Well Name: TEXAKOMA FEDERAL 7	Well Location: T30N / R12W / SEC 7 / NENW / 36.832291 / -108.141694	County or Parish/State: SAN JUAN / NM
Well Number: 2	Type of Well: CONVENTIONAL GAS WELL	Allottee or Tribe Name:
Lease Number: NMNM047	Unit or CA Name:	Unit or CA Number:
US Well Number: 3004530527	Well Status: Producing Gas Well	Operator: HILCORP ENERGY COMPANY

Notice of Intent

Attachment to notice of Intention to Abandon

Well: Taxakoma Federal 7 2

CURRENT WELLBORE SCHEMATIC

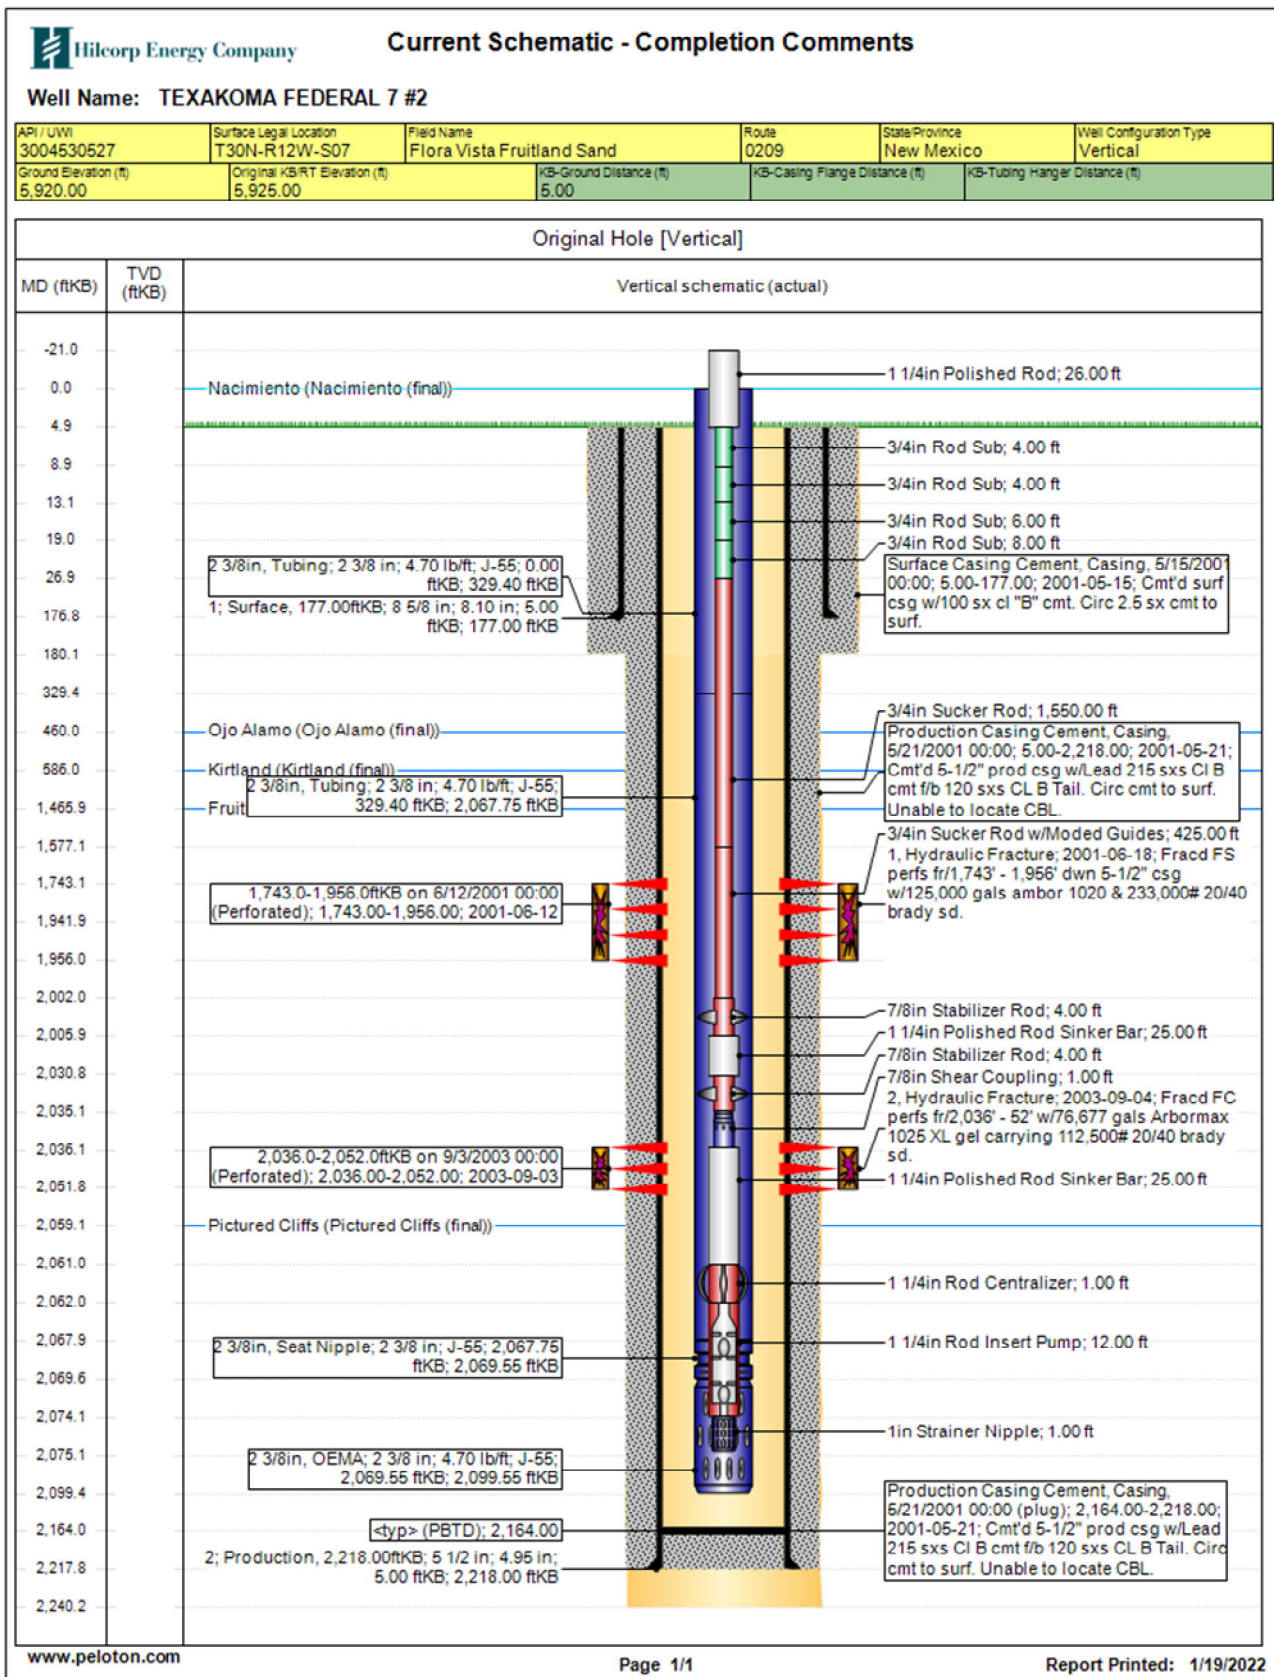
1. Plugging operations authorized are subject to the attached "General Requirements for Permanent Abandonment of Wells on Federal and Indian Lease."
2. The following modifications to your plugging program are to be made:
 - a) Pump a volume of cement below the CICR at 1693' to completely isolate the Fruitland Coal from the Pictured Cliffs. This will satisfy the requirement of adding a plug to cover the Pictured Cliffs formation at 2059' recommended in the BLM Geology Report.
3. Farmington Office is to be notified at least 24 hours before the plugging operations commence at (505) 564-7750.

- Add a plug to cover the Pictured Cliffs formation top at 2059'.

- The plugs proposed in the P&A procedure, with recommended changes, will adequately protect any freshwater sands in this well bore.
- Fruitland perms 1743' – 1956' and 2036' – 2052'.
